## **RK3308 Series S-Version Chip**

### **Hardware Design Modification Introduction**

RK3308 old process chip is pin to pin compatible with RK3308 series S-version chip, and the circuits of them can be designed compatible. But it is necessary to pay attention to the following modification points and adjust the related components.

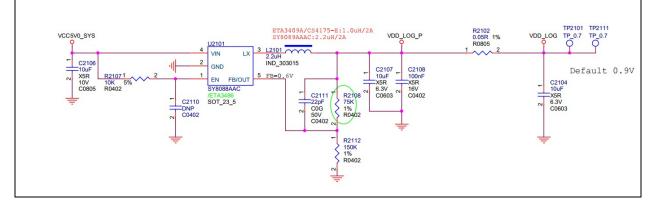
Old process chip VDD\_LOG power supply circuit parameters are as shown in the figure below. The Typical value is 1.0V, and the actual circuit default value is 1.04V.

S-version chip VDD\_LOG power supply circuit parameters are shown in the figure below, and the Typical value is 0.9V, R2108 is changed to 75K 1%.

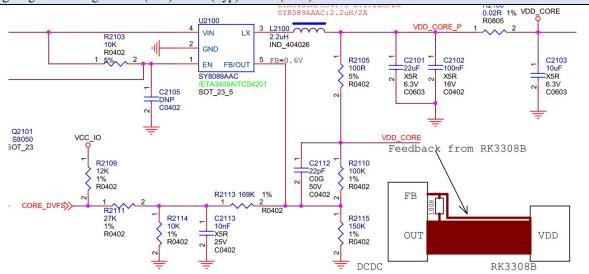
Old process chip VDD\_CORE power supply circuit parameters are shown in the figure below. Typical value is 1.0V. Voltage regulation range: 0.826 (min)-1.015 (Typ)-1.34V (Max)

S-version chip VDD\_CORE power supply circuit parameters are the same as old process chip.

The circuit is consistent with old process chip, and the state after powered-on/standby is controlled by the software through the PWM pin, and the software configuration of frequency-voltage table (opp table) needs to be updated

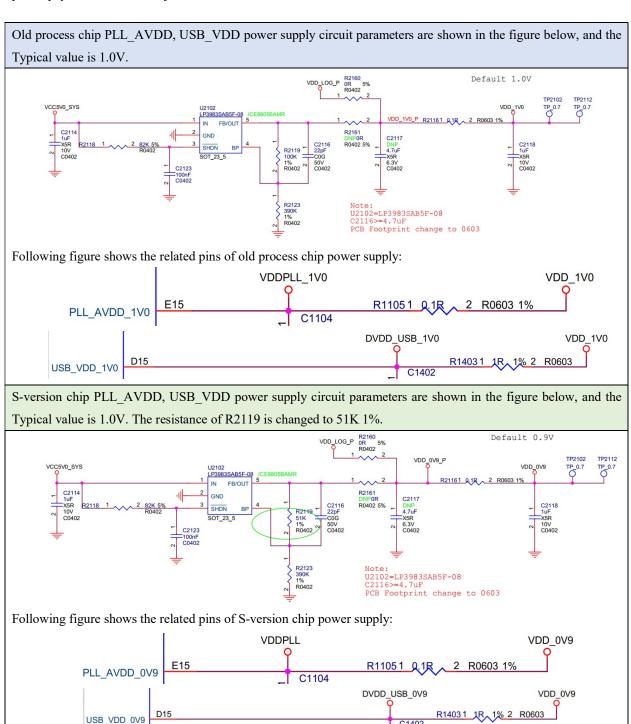
By default, VDD\_1V0 is powered from the VDD\_LOG supply, that means the source of VDD\_1V0 is the same buck DC-DC. VDD\_1V0 takes power from VDD\_LOG, and the voltage is the same as VDD\_LOG. As shown below, LDO U2102 is only a reserved design and is not stuffed as default. For the design of separate power supply, please pay attention to the adjustment of the R2119 resistance value.
